# PRODUCT BULLETIN

**Bulletin No:** PB291

New Long G1 Series Blade Sets (Sample image shown)

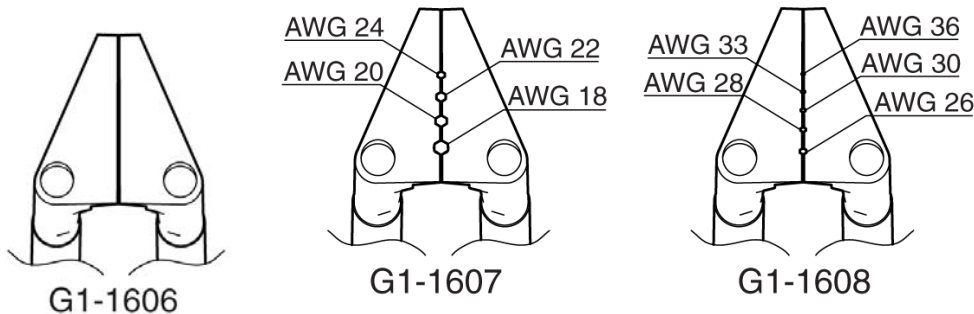
These new Hakko G1 Series Blade Sets have long blade edges for more stable stripping. Duplication of the 24AWG and 26AWG notches have been eliminated while positioning of the notches has been adjusted to improve thermal stripping performance. The extended toe of each blade set can also be used as a hot knife for trimming.
